ADDENDUM #1

Prescott Park Pavilion Building 2013
Bid Proposal #18-14

This Addendum forms part of the original document marked: Bid #18-14 Prescott Park Pavilion Building 2013.

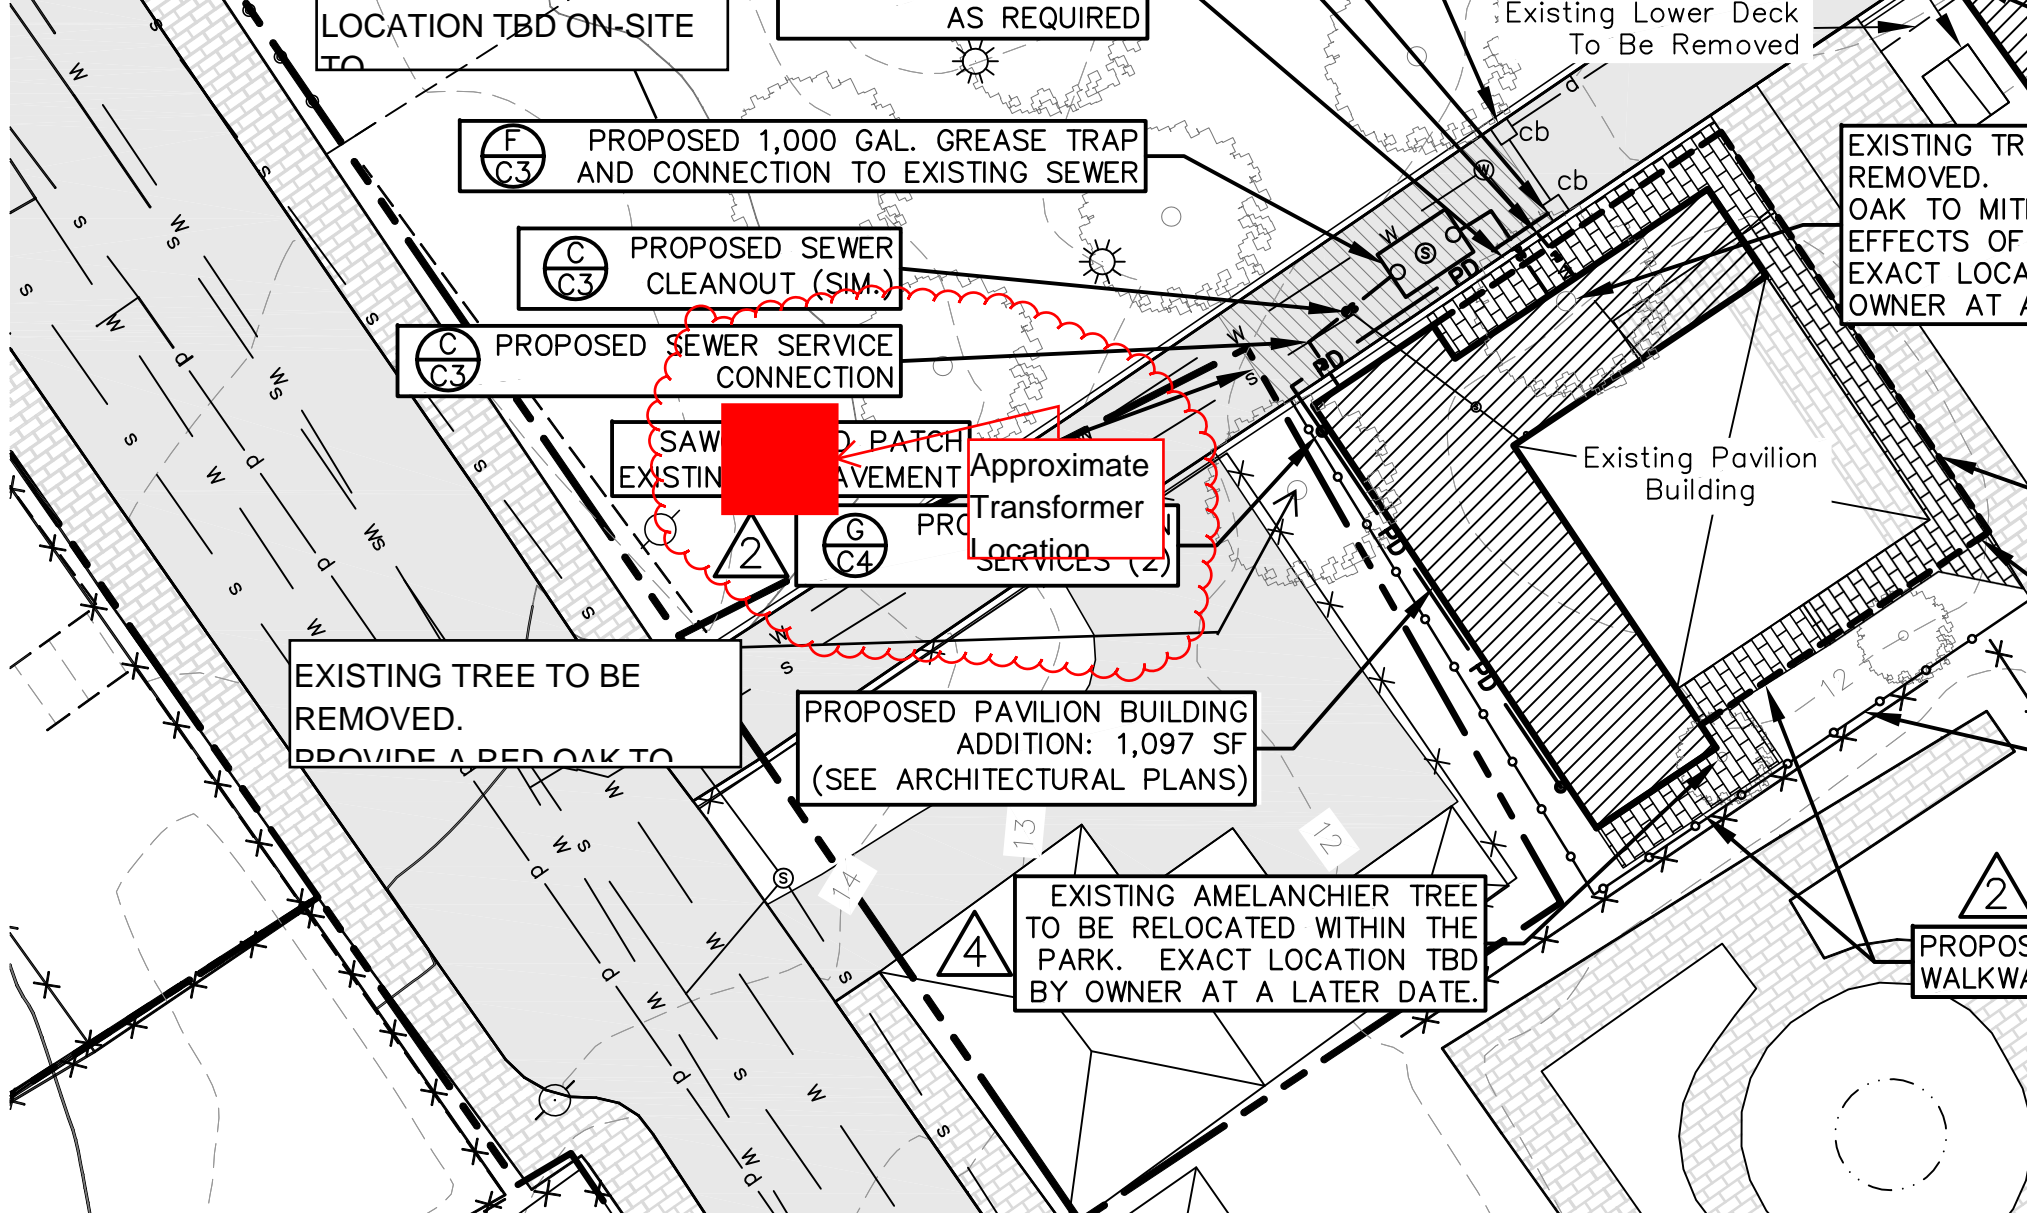
- 1) Drawing E2 shows a new main distribution panel in the support building which will feed the new panels in the pavilion. Is the main distribution panel, along with the other panels in the support building new or are they existing to remain?

- 13) We are not clear on the electrical service as shown. We did not see anywhere on the drawings where it is telling us where it is coming from or if it is existing. It shows a line diagram of 1200A 120/208 MDP w/ P1,P2, and L1 coming off of it.

The new panels in the Pavilion will be fed from the existing Utility Transformer that is approximately 50' to the West of the new panel locations within the Pavilion. (See attached site sketch and photo)

See response to Question #1.

Approximate Transformer Location
